Access Compliance Report Public Rights-of-Way (Curb Ramps)

Main Street: WINDMILL_AVE		Cross Street: N/A		Location:	S
ADA ID: RPRK211110114445	Ramp Type: Type 4 - Parallel	Initial Pass/Fail: Fail	Overall Compliance: No	Severity Score:	2

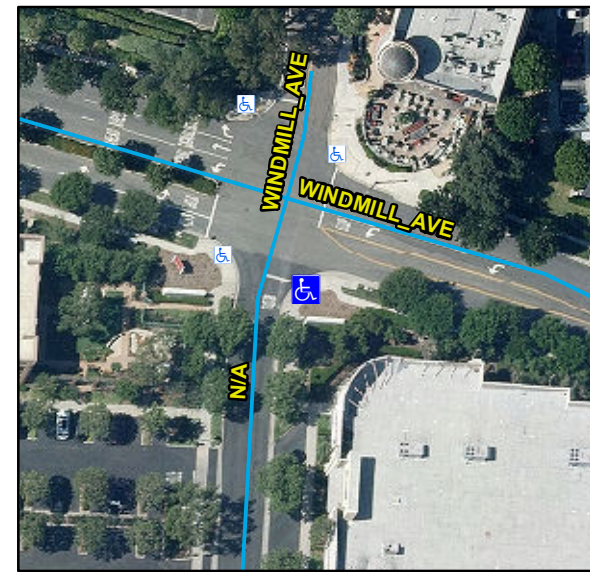
Compliance	Description	Data	Compliance	Description	Data
N/A	Ramp Length LT (in)	134	N/A	Ramp Length RT (in)	129
Yes	Ramp Width LT (in)	88	Yes	Ramp Width RT (in)	88
Yes	Ramp Run Slope LT (%)	7.6	Yes	Ramp Run Slope RT (%)	2.7
No	Ramp Cross Slope LT (%)	2.4	No	Ramp Cross Slope RT (%)	2.7
N/A	Landing Present	N/A	N/A	DWS Provided	N/A
N/A	Landing Length (in)	N/A	N/A	DWS Contrast	N/A
N/A	Landing Width (in)	N/A	N/A	DWS Length (in)	N/A
N/A	Landing Run Slope (%)	N/A	N/A	DWS Full Width	N/A
N/A	Landing Cross Slope (%)	N/A		DWS Offset Type	N/A
N/A	Landing Movement Obstructed?	N/A	N/A	DWS Offset Left (in)	N/A
	Landing Movement Type	N/A	N/A	DWS Offset Right (in)	N/A
N/A	Landing Shared	N/A			
N/A	Clear Space	Yes			
N/A	Clear Space To Crosswalk (in)	N/A			
N/A	Marked Crosswalk 1	No	N/A	Marked Crosswalk 2	No
	Crossing 1 Direction	NE		Crossing 2 Direction	NW
	Marked Crosswalk 1 Width (in)	N/A		Marked Crosswalk 2 Width (in)	N/A

N/A	Ramp Inside Crosswalk 1	N/A	N/A	Ramp Inside Crosswalk 2	N/A
	Crossing 1 Slope (%)	3.7		Crossing 2 Slope (%)	0.2
	Crossing 1 Cross Slope (%)	1.6		Crossing 2 Cross Slope (%)	2.2
N/A	Gutter Ponding	N/A	N/A	Curb Slope	10.6
Yes	Gutter Lip Height (in)	0		Road Run Slope (%)	3
N/A	Gutter Run Slope (%)	N/A		Road Cross Slope (%)	0.6
N/A	Gutter Cross Slope (%)	N/A	No	Perpendicular Joint Present	No
Yes	Overall Surface Condition	Acceptable			
	Cross Gutter Present?	No		Spandrel Present?	No
	Replace Cross Gutter?	N/A		Replace Spandrel?	N/A

Remove & Replace Curb Ramp With Two New Directional Ramps or Equivalent.
